SEWAGE DISPOSAL SYSTEM

SUBDIVISION Sand Hill Acres LOT 12 ROAD 12026 Lamplighter Drive

RE: Sand Hill Acres, Lot #12
12026 Lamplighters Drive
Well Permit #HO-88-0668

DESIGNED JME	SITE DEVELOPMENT PLAN LOT 12 SAND HILL ACRES SECTION 3 AREA 2 3RD ELECTION DISTRICT HOWARD COUNTY, MARYLAND	SCALE 1" = 50'
DRAWN PS BAL		DRAWING 1 OF 1
CHECKED JME		JOB NO. 94-109
DATE 3-22-96		FILE NO. 94-109X
		For: ALTIERI HOMES 3017 Red Branch Road Columbia, Md. 21045

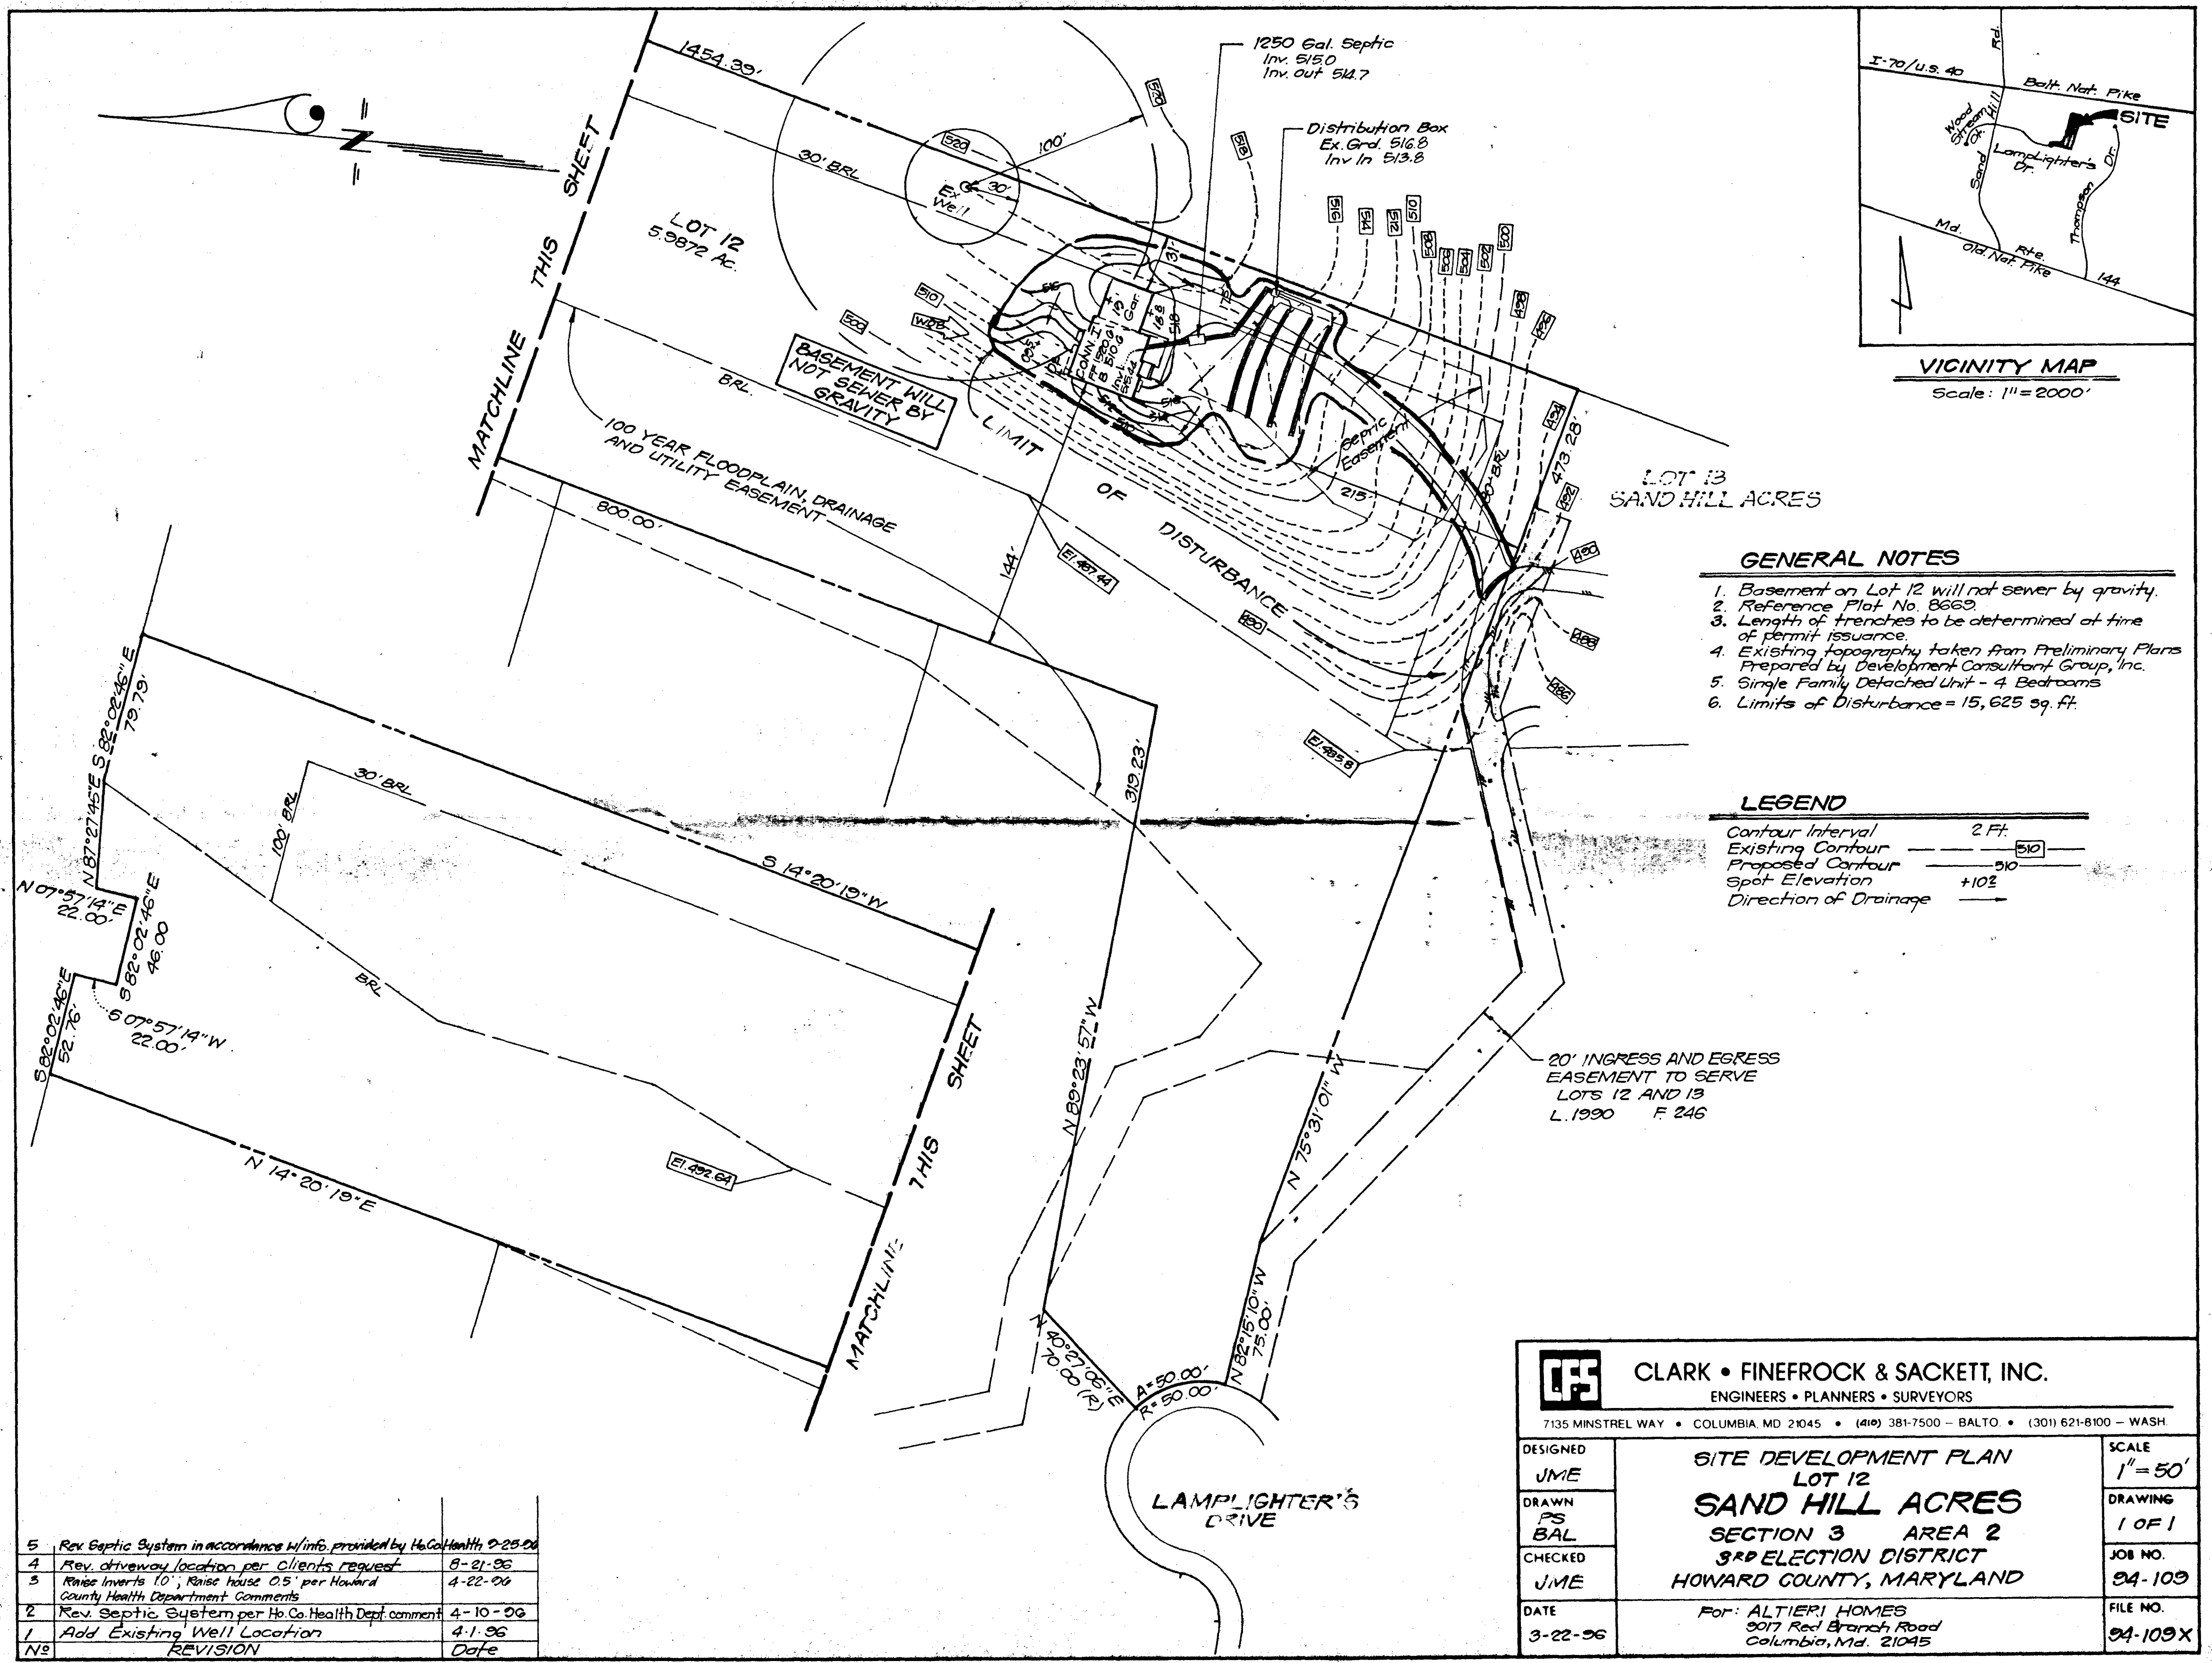
- 7) as a result of the site inspection August 22, 1996, it was determined that the septic system was not accurately installed, that the actual driveway location differed from that shown on the approved BP plan and that the house may have been moved from the approved BP site plan location

No.	REVISION	Date
5	Rev Septic System in accordance w/info. provided by HoCo Health 9-25-06	
4	Rev. driveway location per Clients request	8-21-06
3	Raise Inverts 10'; Raise house 0.5' per Howard County Health Department Comments	4-22-06
2	Rev. Septic System per Ho. Co. Health Dept. comment	4-10-06
1	Add Existing Well Location	4-1-06
